Development Application and Planning Proposal Review

NSW Planning Portal Concurrence and Referral

| Authority | Authority's Reference | Agency Concurrence and Referral | Authority Contact | Authority Notification | Submission Due | Submission Made |
|----------------|-----------------------|---------------------------------|-------------------|------------------------|----------------|-----------------|
| Camden Council | DA/2022/742/1 | CNR-43544 | East DevAdmin | 4/08/2022 | 25/08/2022 | 5/08/2022 |

| Address | Land Title |
|------------------------------------|---------------------|
| 28 Wallarah Circuit, Gregory Hills | Lot 3257 DP 1243285 |

DRAWING NO.
DA.04

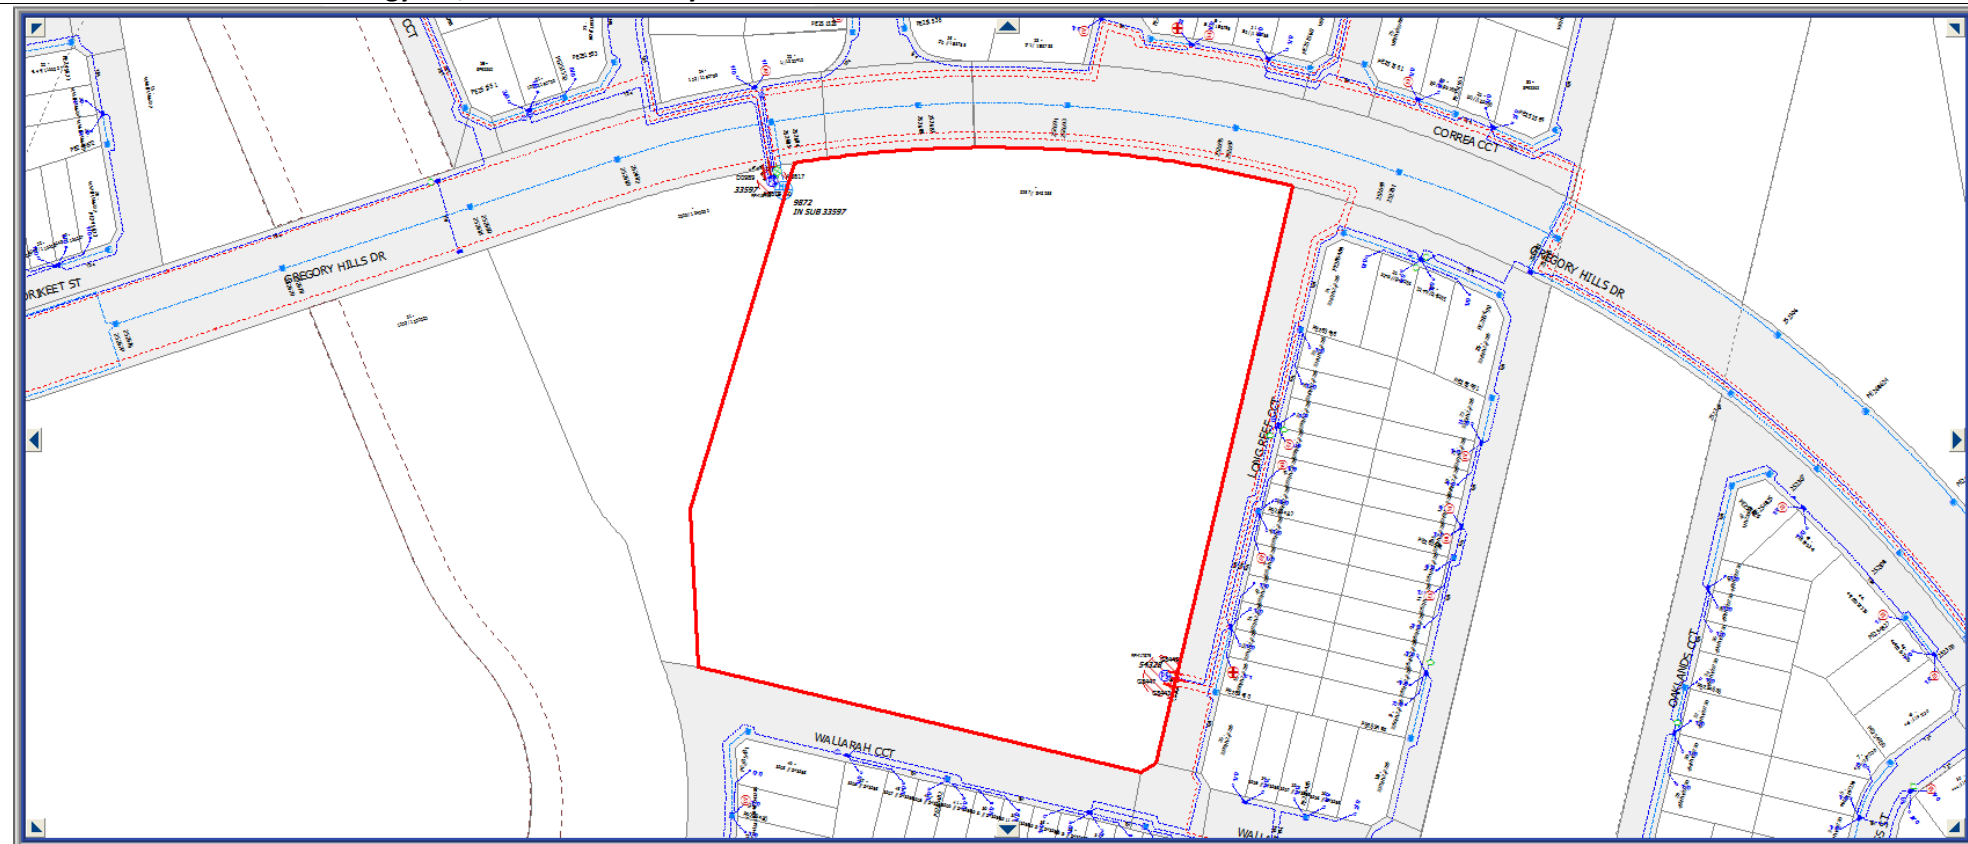
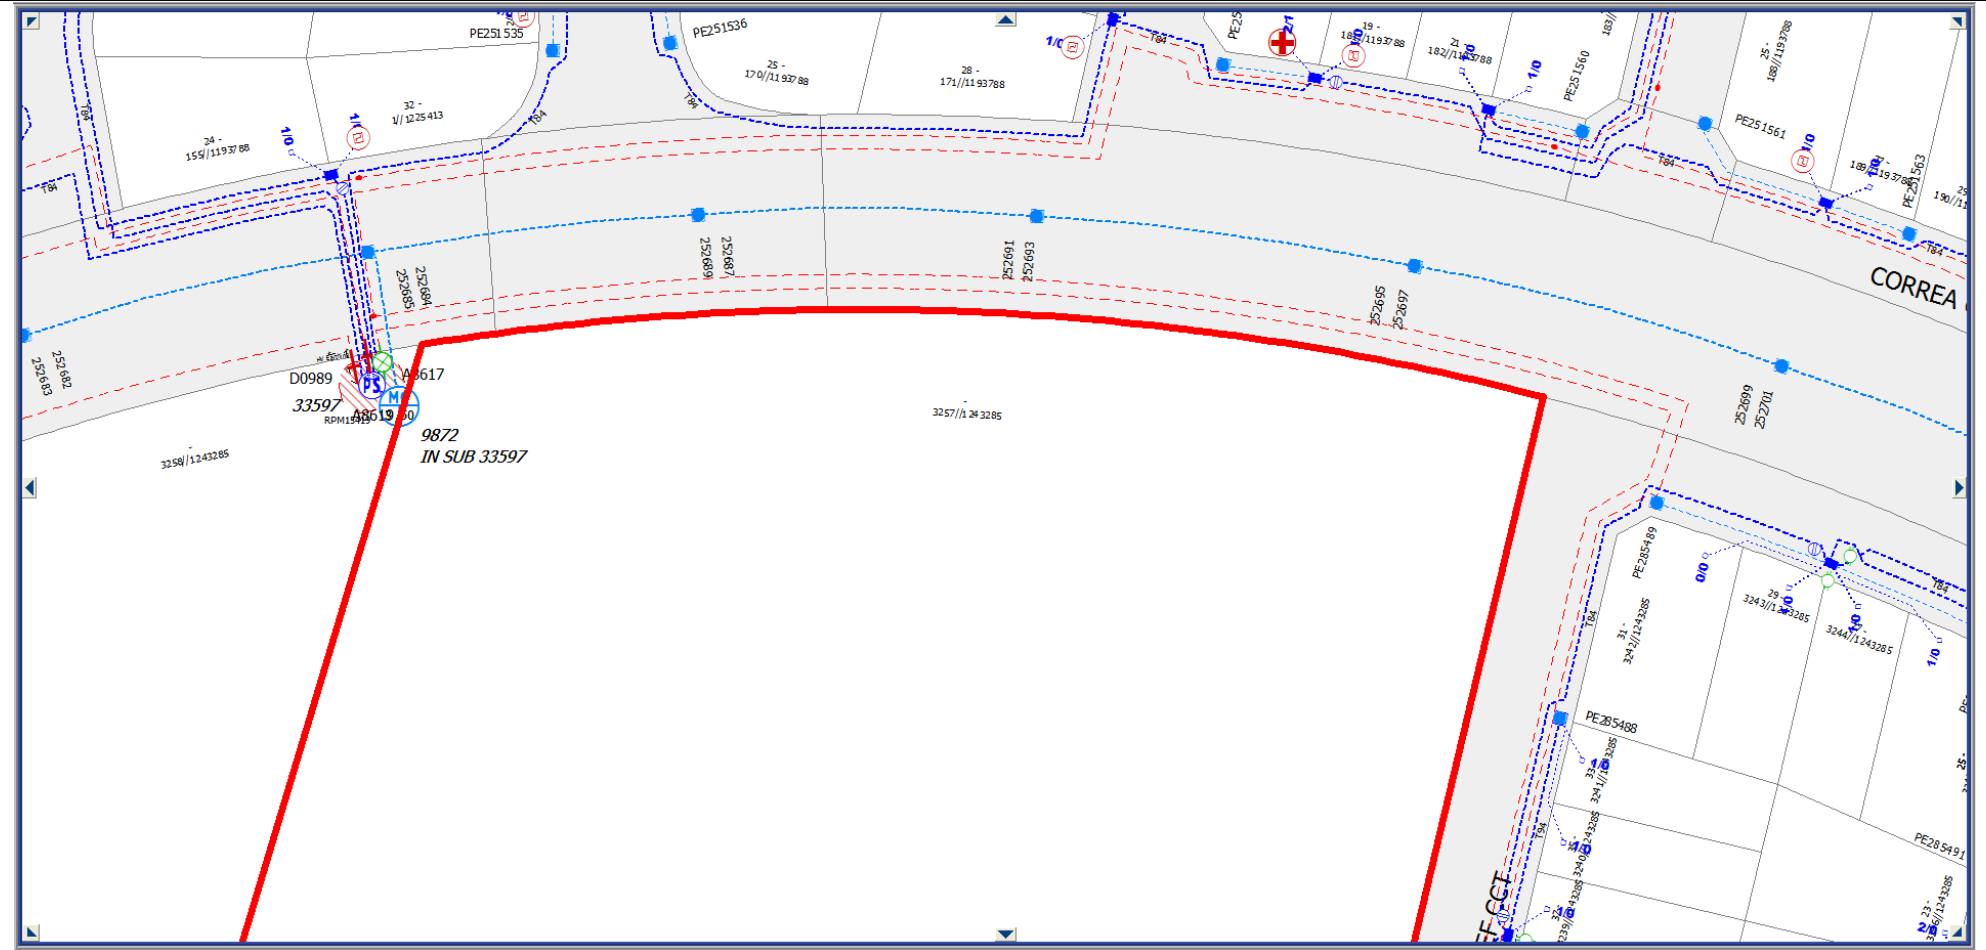
| <ul style="list-style-type: none"> The Statement of Environmental Effects does not appear to address the easement or restrictions for fire rating and swimming pool or spa affecting the site for the padmount substation. The Site Plan shows the temporary school is located to the northern and eastern parts of the site and not encroaching the easement or restriction for fire rating. There is no swimming pool or spa proposed. All activities affecting an easement or relevant to the restrictions for padmount substations (even if not part of the Development Application) need to be referred to Endeavour Energy's Easement Officer for assessment and possible approval if they meet the minimum safety requirements and controls. However please note that this does not constitute or imply the granting of approval by Endeavour Energy to any or all of the proposed encroachments and / or activities within the easement or restrictions. <p>For further information please refer to the attached copies of Endeavour Energy's:</p> <ul style="list-style-type: none"> ○ Guide to Fencing, Retaining Walls and Maintenance Around Padmount Substations. ○ Mains Design Instruction MDI 0044 'Easements and Property Tenure Rights' which deals with activities / encroachments within easements. <p>Please note Endeavour Energy's Easement Officers do not have access to the NSW Planning Portal. To resolve the easement management matters direct contact with the Easement Officer should be made.</p> <ul style="list-style-type: none"> Prudent avoidance measures appropriate to any electricity infrastructure on and near the site should when reasonably possible be implemented. <p>Whilst there may be no restrictions in legislation that stop sensitive uses such as schools, pre-schools, day / child care centres being placed next to electricity infrastructure, prudent avoidance measures should however be implemented.</p> <p>As a guide please refer to the Endeavour Energy's Mains Design Instruction MDI 0044 'Easements and Property Tenure Rights', Table 1 – 'Minimum easement widths'. With the observance of these separation distances, electric and magnetic fields (EMF) should not exceed the recommended magnetic field public exposure limits.</p> <p>Nonetheless the applicant may wish to commission an independent review to provide an overall assessment and the consideration and adoption of prudent avoidance principles.</p> <ul style="list-style-type: none"> The applicant should check with their Accredited Service Provider (ASP) responsible for the network connection to the site that for the padmount substation the earthing has been designed to comply with the 'special location' requirements under Endeavour Energy's Earthing Design Instruction EDI 001 – 'Earthing design risk assessment'. | |

- Screening vegetation around a padmount substation should be planted a minimum distance of 800mm plus half of the mature canopy width from the substation easement and have shallow / non-invasive roots. This is to avoid trees growing over the easement as falling branches may damage the cubicle and tree roots the underground cables. All vegetation is to be maintained in such a manner that it will allow unrestricted access by electrical workers to the substation easement all times.

Site Plan from Endeavour Energy's G/Net Master Facility Model

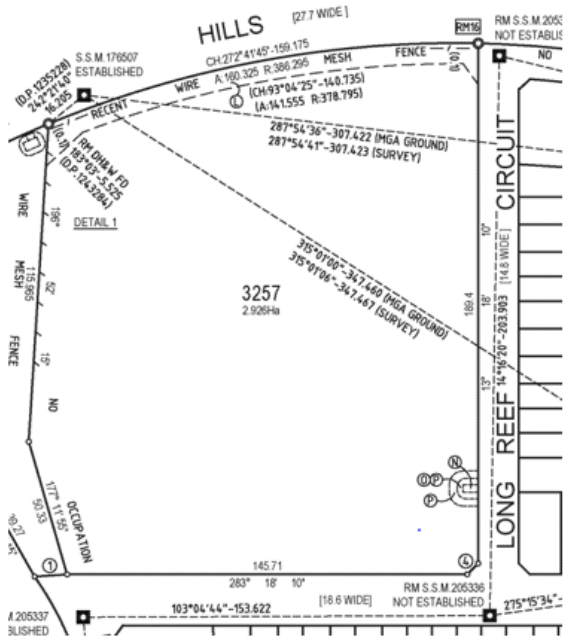
- An easement and restrictions for fire rating and swimming pool or spa benefitting Endeavour Energy (indicated by red hatching) for padmount substation no. 54328.
- Low voltage and 11,000 volt / 11 kilovolt (kV) high voltage underground cables and underground earth cables to the Long Reef Circuit road verge / roadway.
- 11 kV high voltage underground cables to the Gregory Hills Drive road verge / roadway.
- Restriction for fire rating for padmount substation no. 33597 near the north western corner of the site to the Gregory Hills Drive road frontage in Howard Park.
